Bid#: 21122

Project: Vernon Hills NCT and Des Plaines River WRF Screening Improvements Project

Subject: Addendum #2

Date: 9/22/21

**20-R-1
RAW WASTEWATER PUMP STATION
UPPER PLAN REMOVAL**

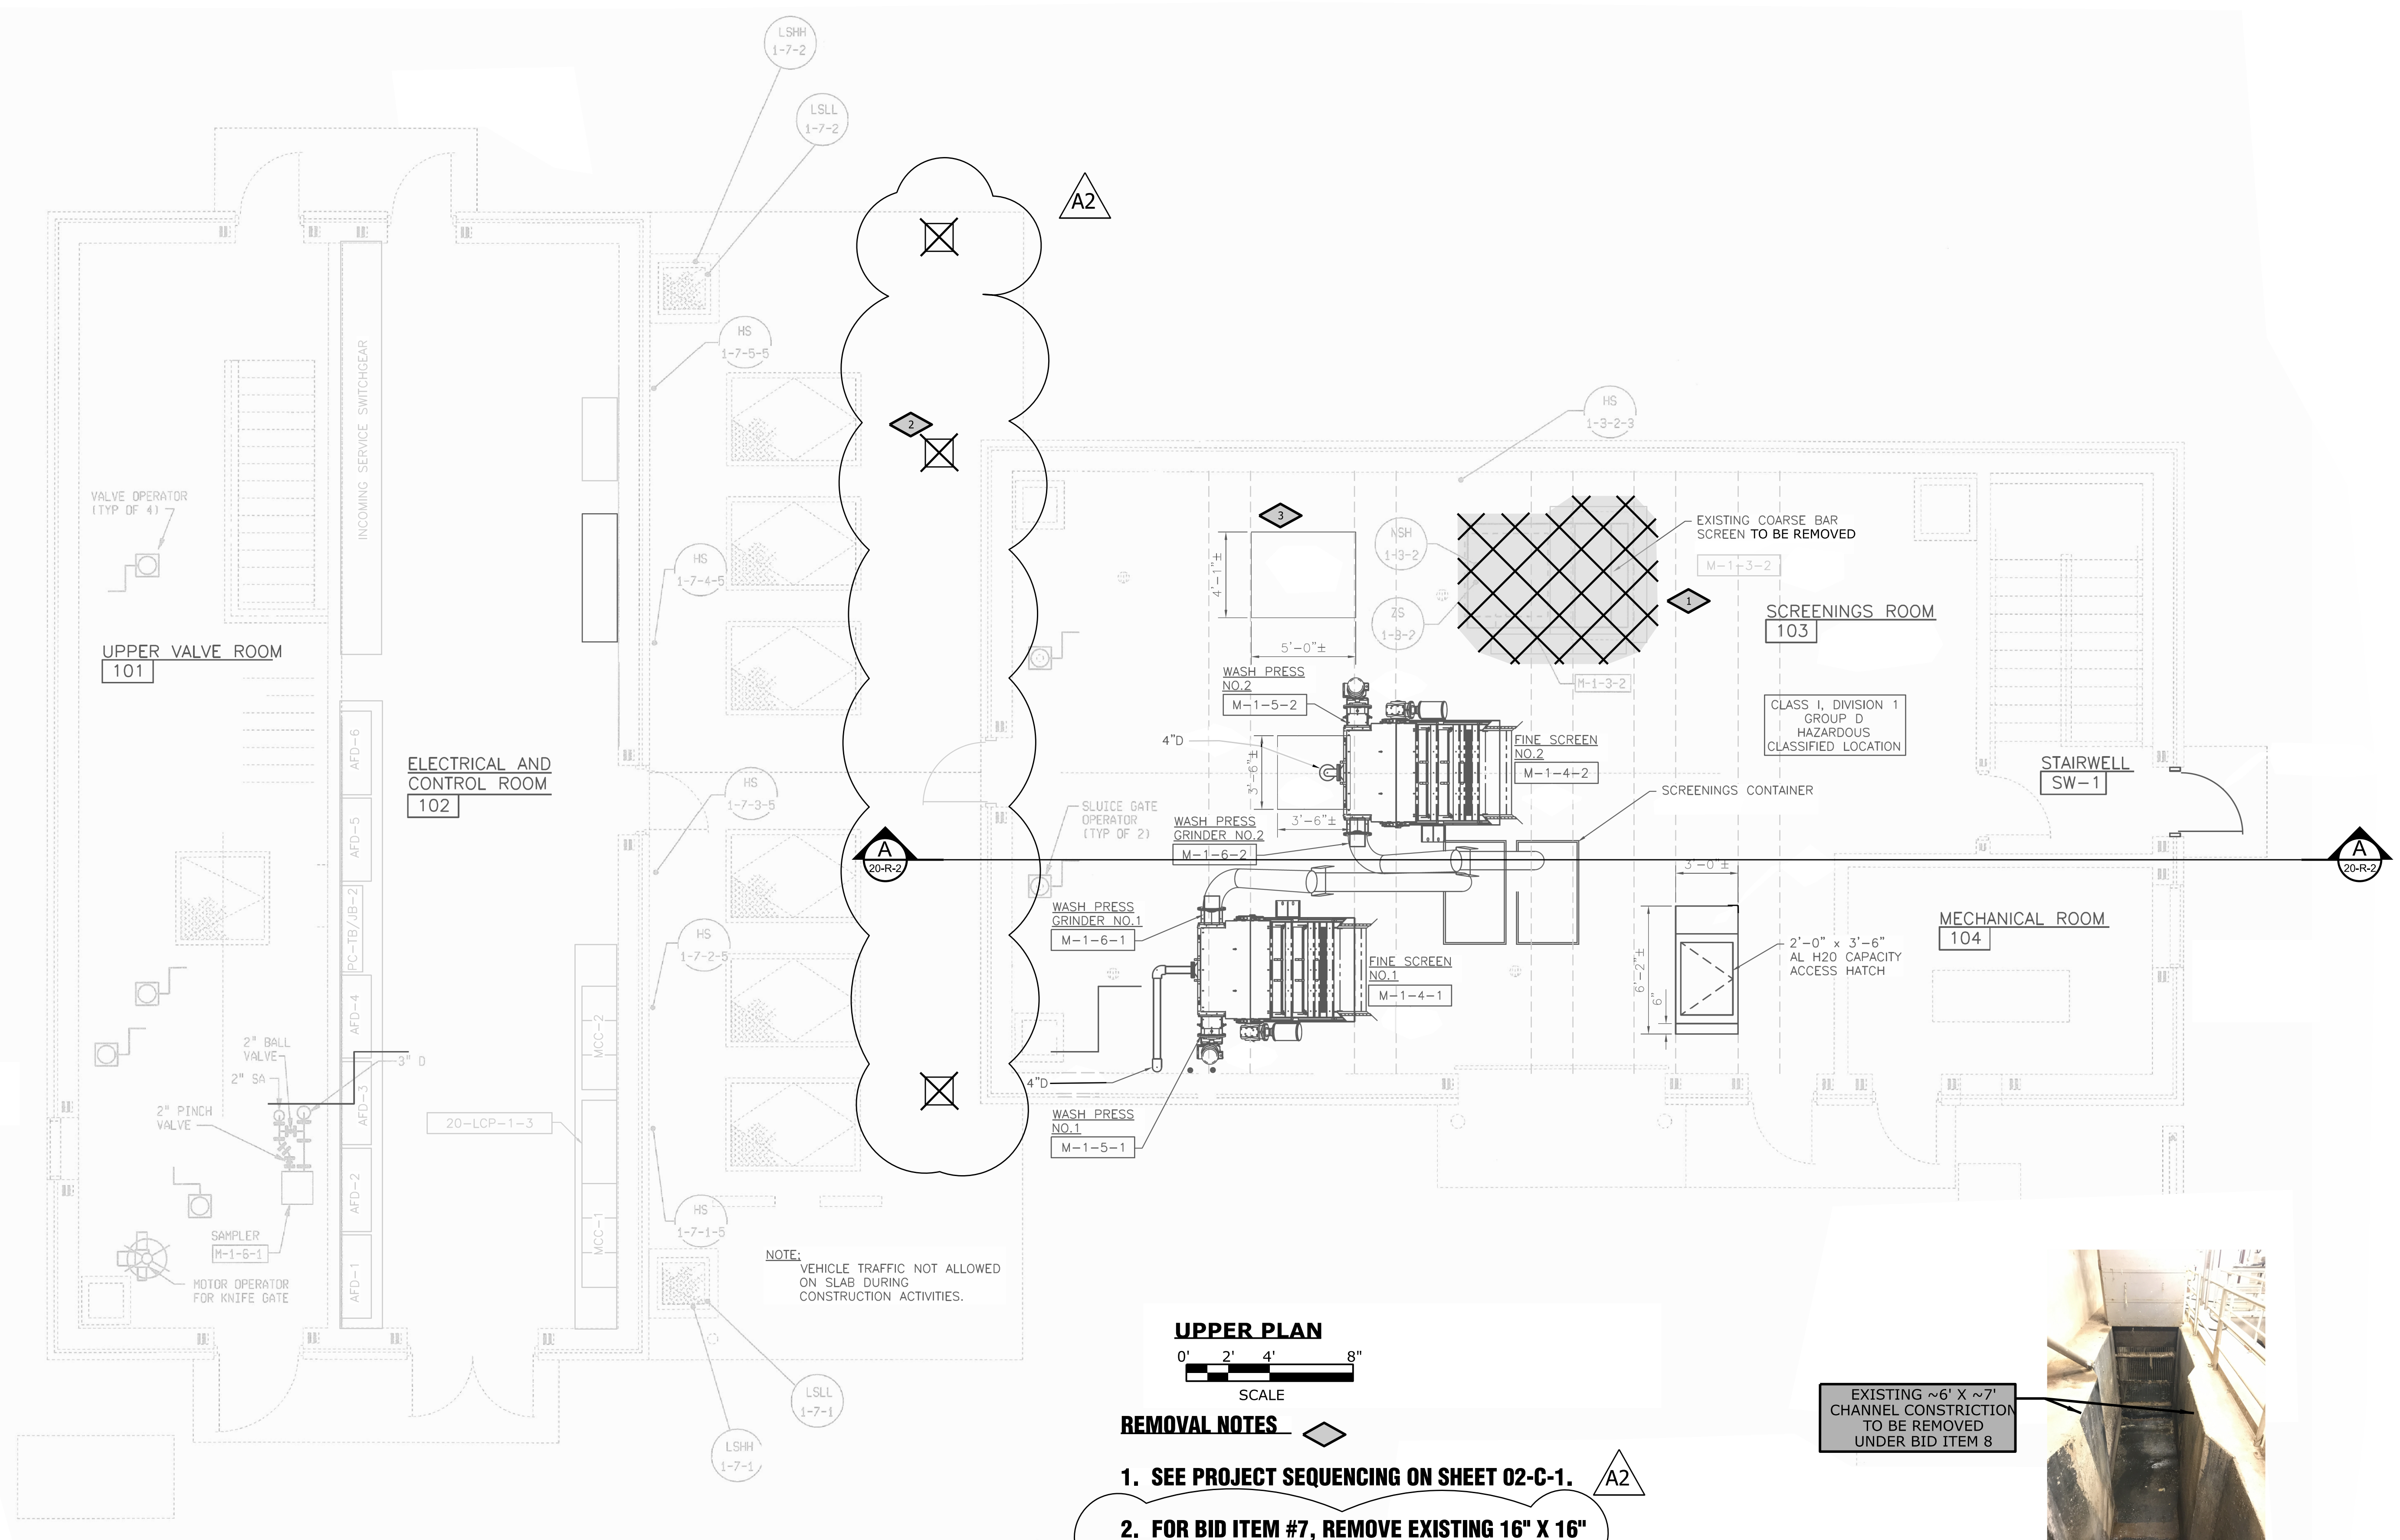
- 1) DPR – As part of Base Bid Item #7, remove 3 existing concrete (approximately 16" x 16" x 2") pads west of bar screen building. See revised sheet 20-R-1.

1. SEE PROJECT SEQUENCING ON SHEET 02-C-1. A2
2. FOR BID ITEM #7, REMOVE EXISTING 16" X 16" CONCRETE PADS.
3. FOR BID ITEM #8, CUT AN APPROXIMATELY 5' WIDE X 5' LONG HOLE IN THE OPERATING FLOOR FOR THE ALTERNATIVE SCREEN LOCATION. REMOVE CHANNEL CONSTRUCTION ON LOWER LEVEL. SEE PHOTO.
